SERVICE BULLETIN

NUMBER: 12-203-16R
DATE: 07/14/16
REVISED: 08/04/21

SUBJECT: Squeaking Sound from Front Seat Buckle

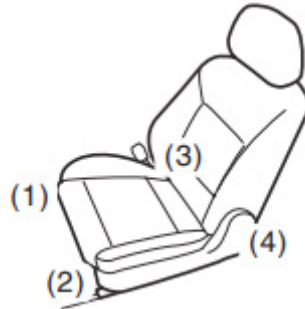
The 3 “tang” seen on the inside of the **OLD** wave washer have been deleted. The new washer also has a goldish-color flurocarbon resin coating. The inside diameter of the **NEW** spring wave washer has been decreased and a small felt added to allow the washer to turn smoother with the buckle and have a better fit on the shoulder portion of the retaining bolt.
